CUYAMA BASIN GROUNDWATER SUSTAINABILITY AGENCY STANDING ADVISORY COMMITTEE

AGENDA

April 25, 2019

Discussion on GSP Public Draft

Figure 1

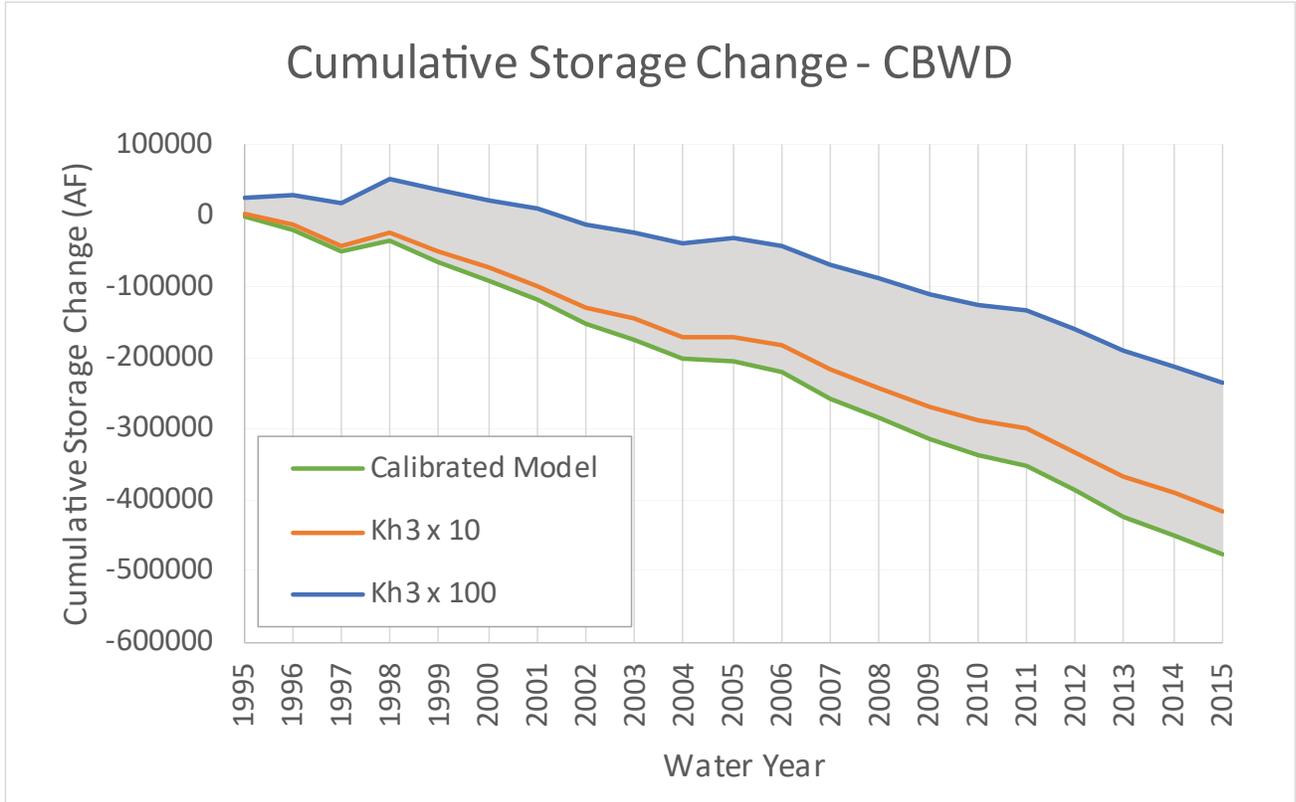
- The model's representation of water-transmitting properties (horizontal hydraulic conductivity, or "Kh") appears to be inconsistent with USGS field-based data in some units. Figure 1 uses statistical box plots to compare the range in reported measured Kh values for the major formations represented by the three model layers to values used in the model. 52% to 71% of the measured Kh values fall within the range delineated by the blue boxes in Figure 1. The red brackets to the left of each boxplot indicate the range in modeled horizontal hydraulic conductivity for the corresponding formations and model layers.

- Figure 1 shows that the range in Kh values for the Younger Alluvium (Model Layer 1) and Older Alluvium (Model Layer 2) generally is consistent with the range in measured values of Kh (i.e., substantial overlap exists between the measured values represented by the box plots, and the modeled ranges represented by the red brackets).

- In contrast, the modeled Kh of the Morales Formation (Model Layer 3) is 10 to 100 times lower than measured Kh values (the modeled range represented by the red bracket is smaller and much lower than the range in actual values represented by the box plot).

Recommendations. EKI recommends that the GSA Board refrain from making decisions related to Projects and Management Actions or pumping allocations based solely on the future overdraft conditions projected by the CBWIRM, as currently presented. It is important to remember that models do not make decisions. Rather, planners and managers make decisions based on model results, and those decisions include other relevant information. While the model is a potentially useful tool for projecting changes in basin conditions in response to proposed management actions, decisions based on model results must consider model uncertainty (how wrong the modeled projections might be).

Figure 2

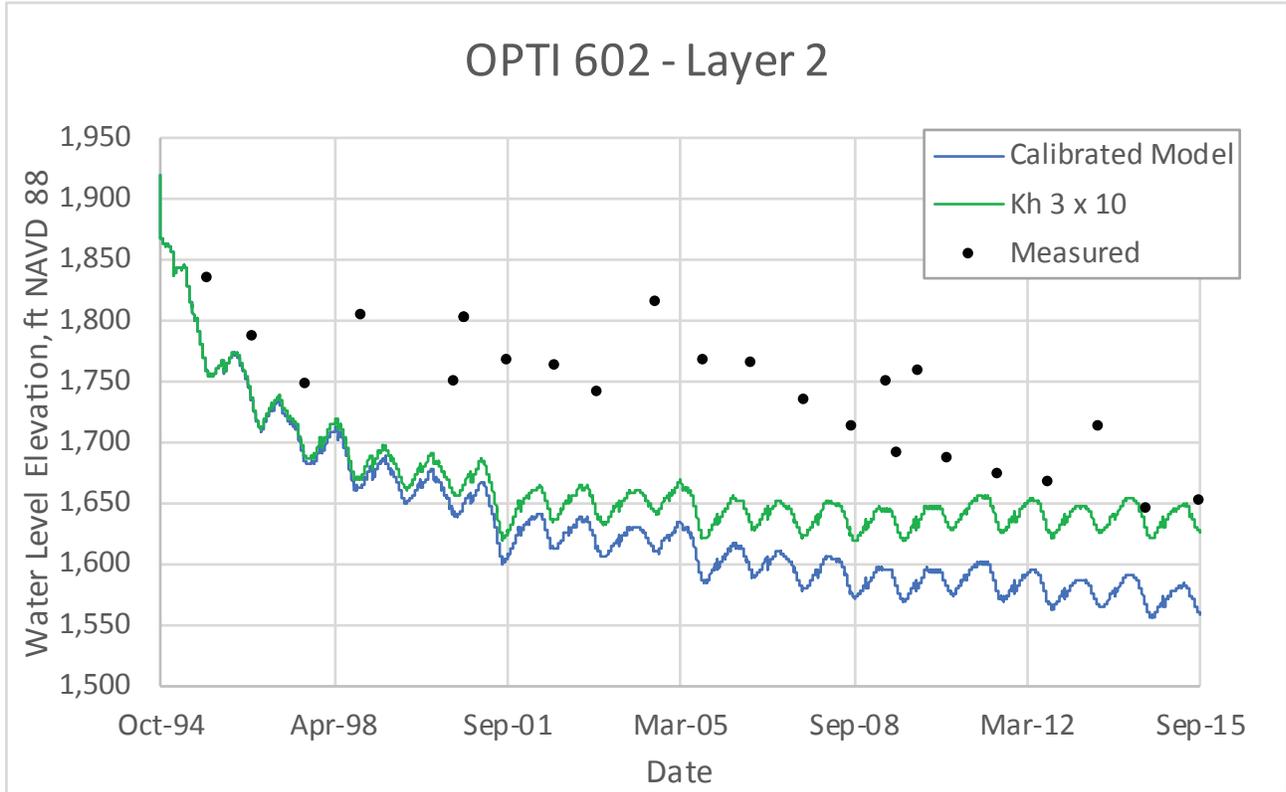
- When the Kh values specified in the model for Model Layer 3 (Morales Formation) are increased by factors of 10 and 100 to make the model inputs more in agreement with field-measured data, the model results indicate that model-calculated storage loss within the Cuyama Basin Water District decreases by 25% to 50% (see Figure 2). The Cuyama Basin Water District represents 34% of the basin area, thus, this uncertainty in predicted storage loss is highly significant. We noted during our review that incorporation of the more-realistic Kh values into the model does not adversely affect model calibration (comparisons between measured and model-calculated water levels) at locations observed within Cuyama Basin Water District (Figure 3).
